FAX TRANSMITTAL SHEET

Project No. 3-1161-510 Page 1 of 8
 Client B.N. Date 4/26/95
 Site SKYKOMISH RIVER By MLG
 Subject SLURRY TRENCH STABILITY App.

RE: Addendum No. 1
Request for Proposal for Construction Services
LNAPL Containment Barrier Wall
BNSF – Skykomish, Washington

CALCULATION.

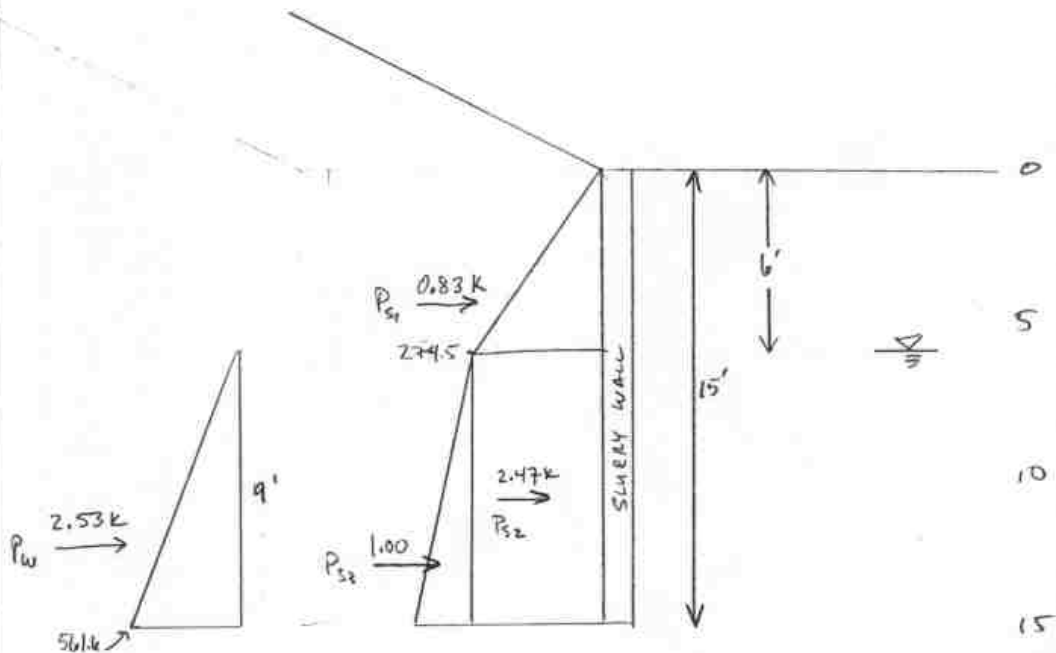
This value is reduced from reference 1 calculations due to a lowering of the groundwater table to a reasonable level and increasing the soil ϕ levee strength to 36° . It is reasonable to assume that adjusting these two parameters to realistic values will also lower the Coulomb trial wedge total force to below 6183 k. \Rightarrow the more conservative analysis remains the Rankine active calculation.

* Suggest that a slurry density of 73 pct is required and a max slurry depth of 1' bgs.

REFERENCE 3

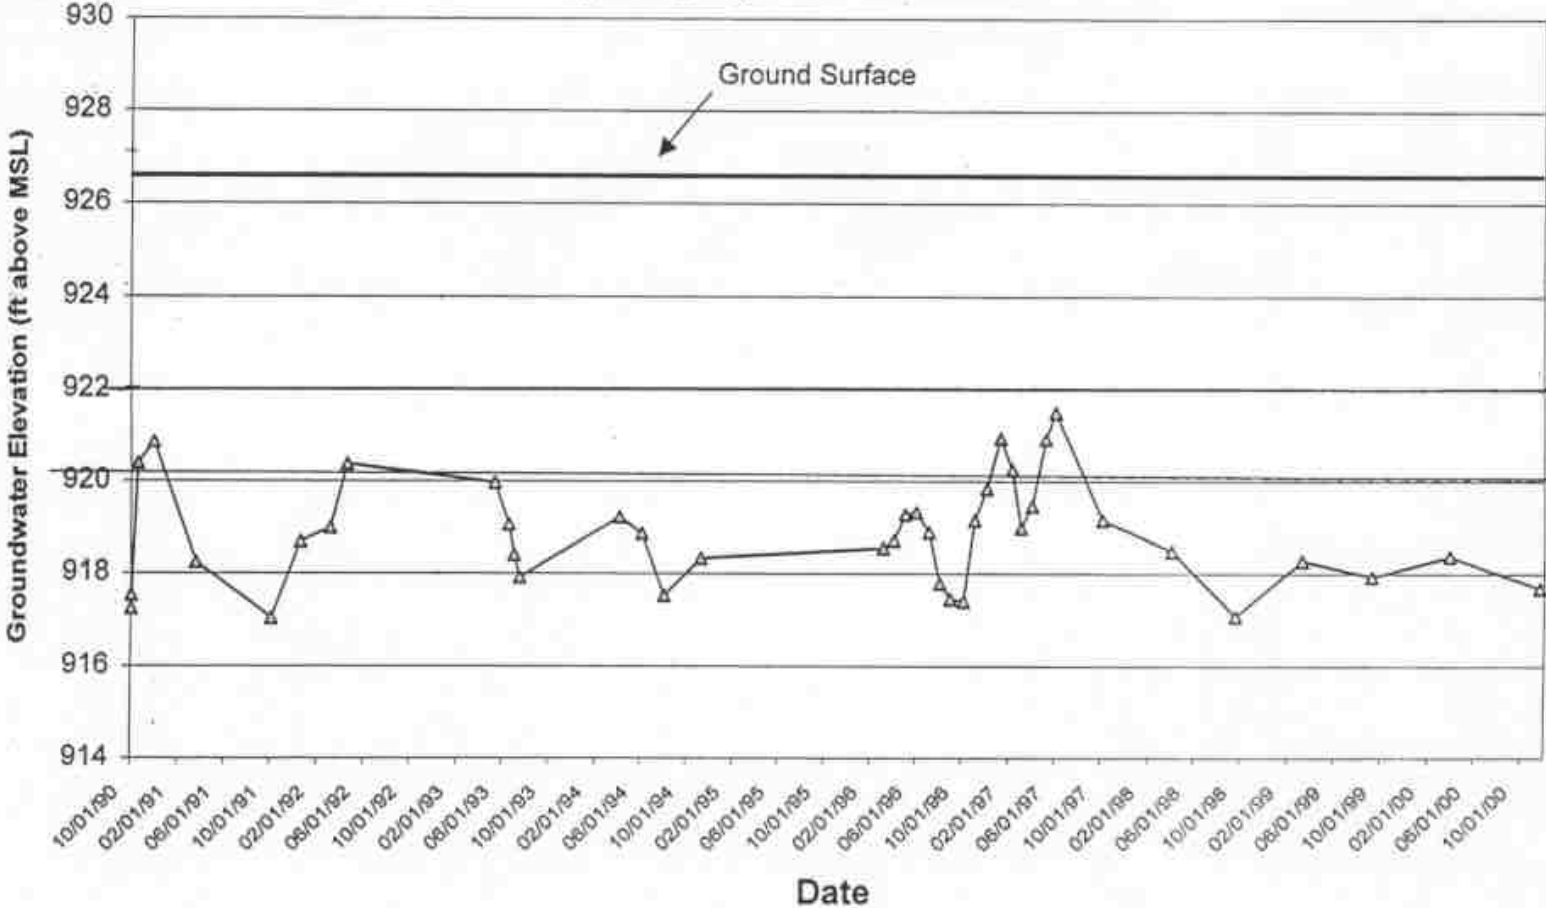
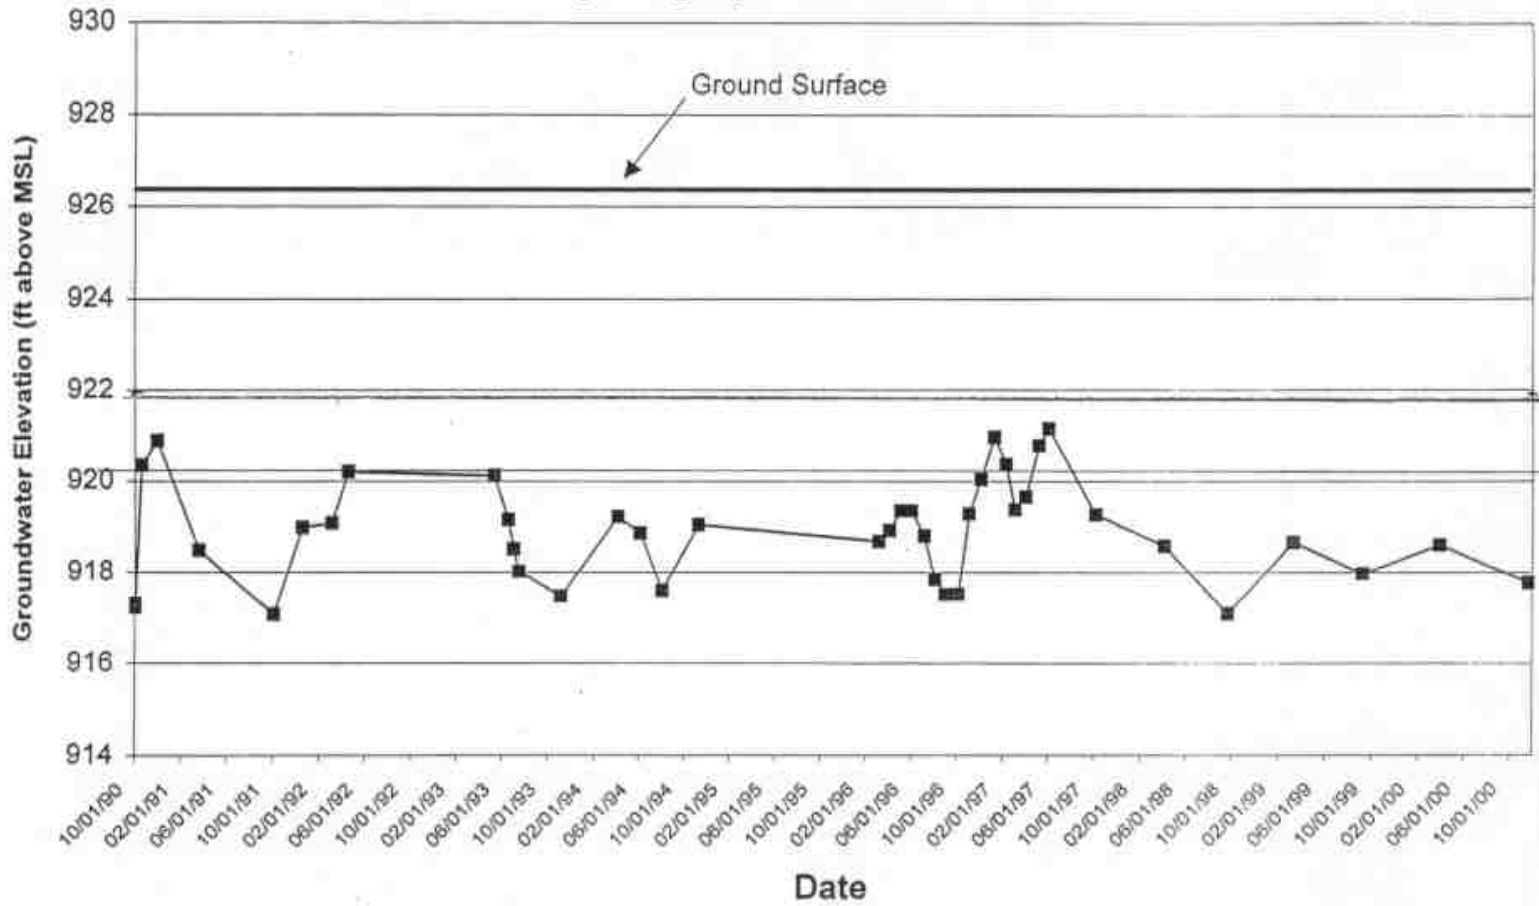
- A) Look @ water table level used in Ref. 1 calculation. The earlier calculation utilized a groundwater table 4.5 feet below the ground surface. The attached hydrographs indicate that a conservative gw would be 6' below the ground surface. This is the highest August level in the last 10 years.

gw level in August every year.

⇒ Change A = lower the groundwater level to 6 ft bgs.

Attachment: Revised Plate 1
Table 2
Figure 2

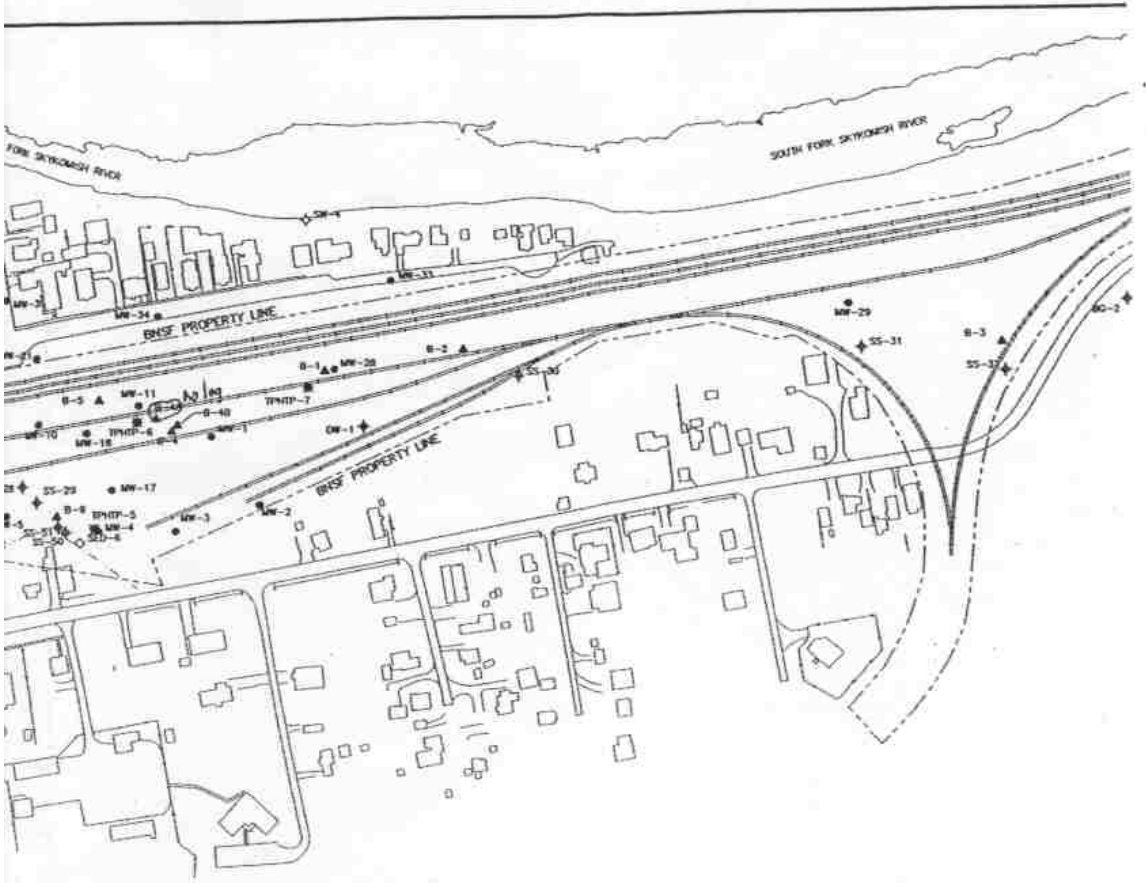
- A-1-7: Construction Staging Area. A modification to the construction staging area has been required to remain clear of the school's drain field. The attached modified Plate 1 indicates the new dimensions of the staging area that will be available during construction.
